# Work Order ID 69125

Item Name: Crosstube Turning Detail

<b>DART AEROSPACE LTD</b>	<b>Work Order:</b> 69125
<b>Description:</b> Crosstube Assembly (205/212/412 High Fwd)	<b>Part Number:</b> D212-664-141
<b>Inspection Dwg:</b> D212-664-141 Rev: D	<b>Page 1 of 1</b>

DRAWING NO. D212-664-141	TITLE XTUBE ASSY (205/212/412 HI FWD)	REV. D	<b>DART AEROSPACE LTD ENGINEERING ORDER</b>		D.E.O. NO. D212-664-141-D-1	SHEET NO. SHEET 1 OF 2	SCALE NTS
DRAWN	CHECKED <i>OP</i>	MFG. APPR. <i>R</i>	APPROVED <i>NA</i>	DE APPR. <i>#</i>			
DATE 11.04.07	DATE 11.04.11	DATE 11.04.12	DATE 11/04/12	DATE 11.04.12

**D212-664-141/-141B  
ASSEMBLY DETAIL**

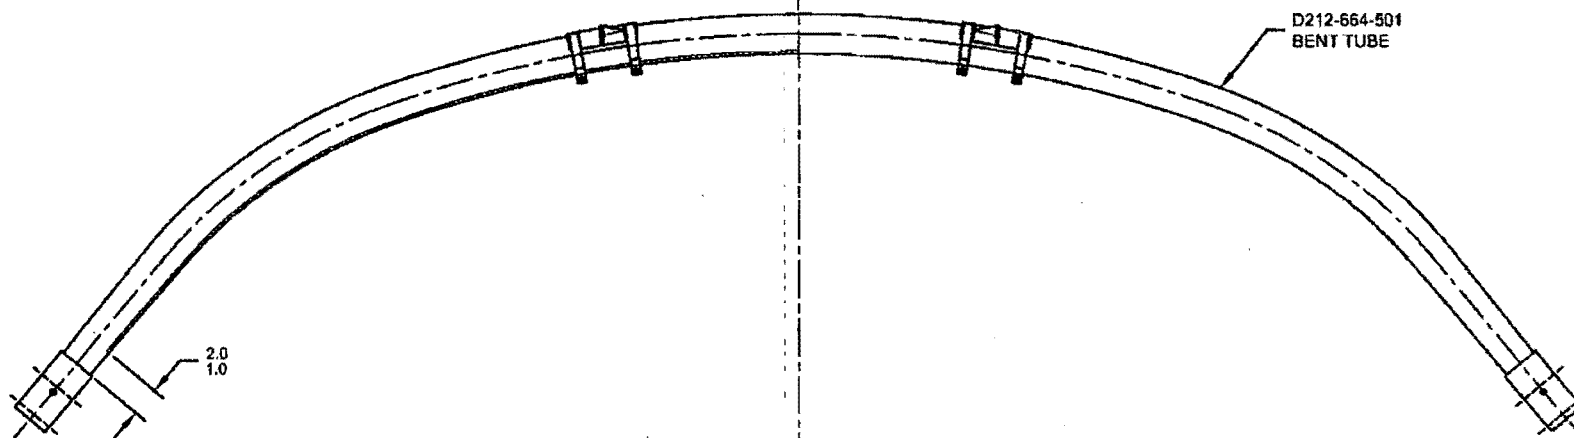
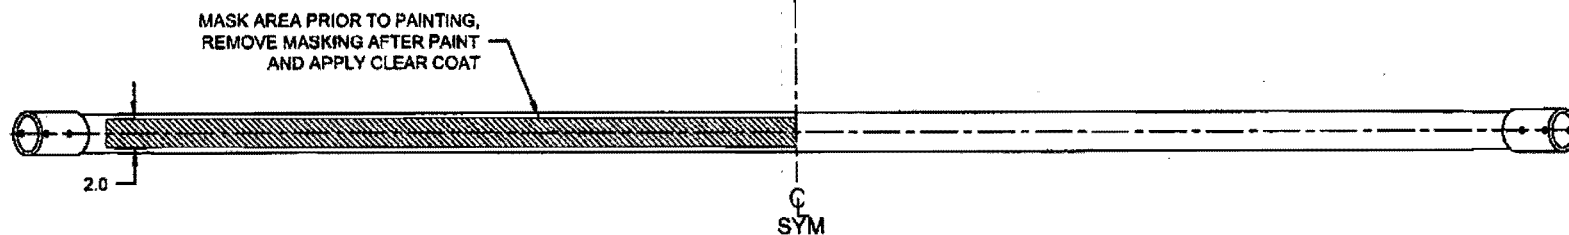
**PURPOSE:**

ADD AN INSPECTION WINDOW TO UNDERSIDE OF CROSSTUBE.

**NOTES 2 OF SHEET 1 IS AMENDED AS FOLLOWS:**

**IS:**

- 2) FINISH: CHEMICAL CONVERSION COAT PER DART QSI 005 4.1  
PRIME INSIDE AND OUTSIDE PER DART QSI 005 4.2  
MASK UNDERSIDE OF CROSSTUBE AS SHOWN (HATCHED AREA) AND  
PAINT OUTSIDE PER DART QSI 005 4.2  
REMOVE MASKING AND APPLY CLEAR COAT

**WAS:**

- 2) FINISH: CHEMICAL CONVERSION COAT PER DART QSI 005 4.1  
PRIME INSIDE AND OUTSIDE PER DART QSI 005 4.2  
PAINT OUTSIDE PER DART QSI 005 4.2
